September 21, 1982

Attention: Ms. Janis B. Kerrigan, Acting Chief
Licensing Branch 3
Division of Licensing

References: (a) Construction Permits CPPR-135 and CPPR-136, Docket
Nos. 50-443 and 50-444
(b) USNRC, Letter, dated April 26, 1982, "Request for
Additional Information - Seabrook Station, Units 1 & 2",
F. J. Miraglia to W. C. Tallman

Subject: Response to 440 Series RAIs; (Reactor Systems Branch)

FIGURE 3.4-4

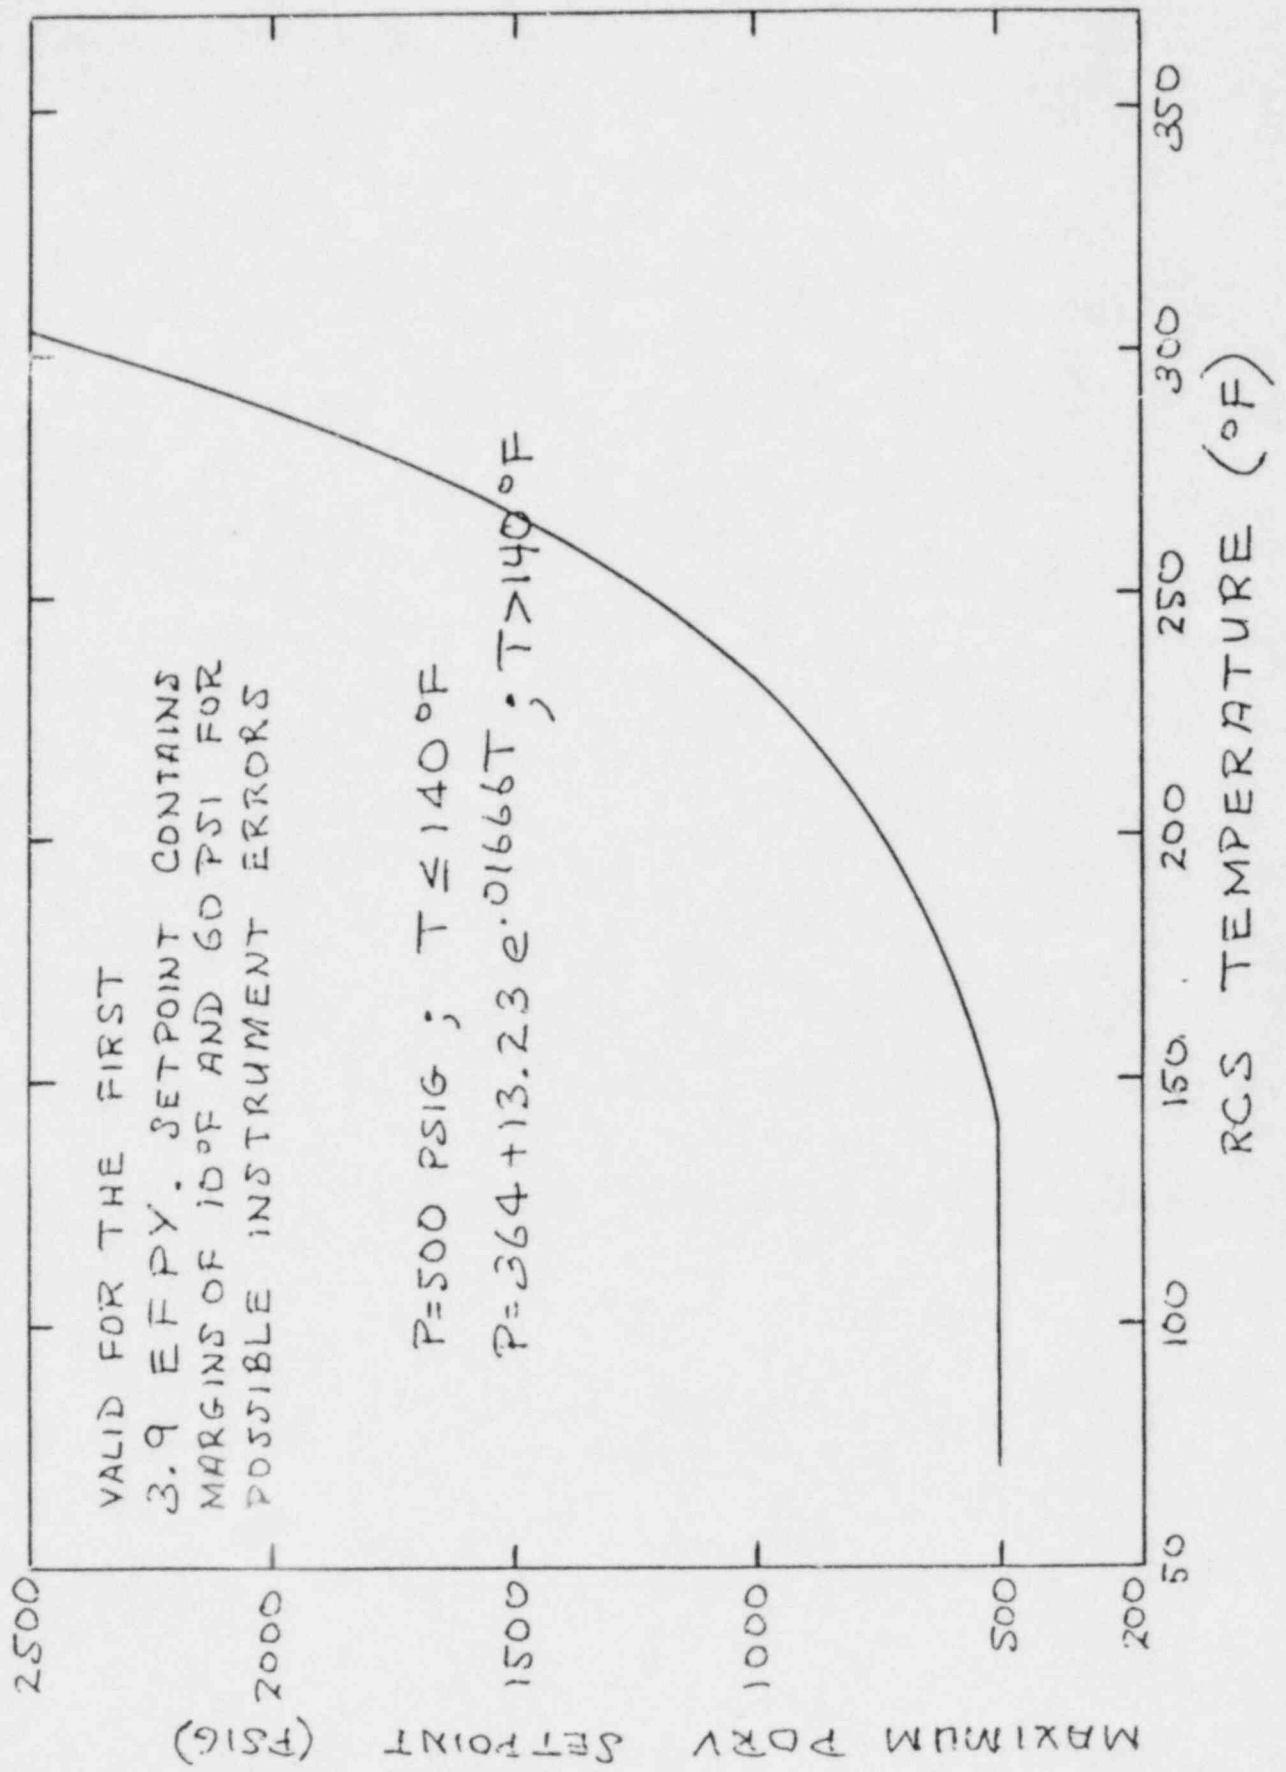
Per the requirements of BTP RSB 5-2, events that are excluded from the analysis, the controls to prevent these events should be included in the Tech. Specs. Address compliance with this requirement.

Technical Specification 3.4.10.3 requires two operable PORV's when the RCS temperature is $\leq 305^{\circ}\text{F}$. Alternatively, the RCS may be depressurized and vented through an equivalent opening. The required PORV setpoint ensures that the RCS is protected from pressure transients which could exceed the limits of Appendix G to 10CFR50. Either PORV has sufficient capacity when the transient is limited to either (1) the start of an idle RCP constrained by Technical Specifications 3.4.1.3 and 3.4.1.4 or (2) the start of an SI or charging pump when the RCS is water solid.

- a. Two power operated relief valves (PORVs) with a lift setting of less than or equal to ~~450 psig~~, or ~~the maximum setpoint defined by Figure 3.4-4~~, or ^{later}
- b. A reactor coolant system vent of greater than or equal to () square inches.
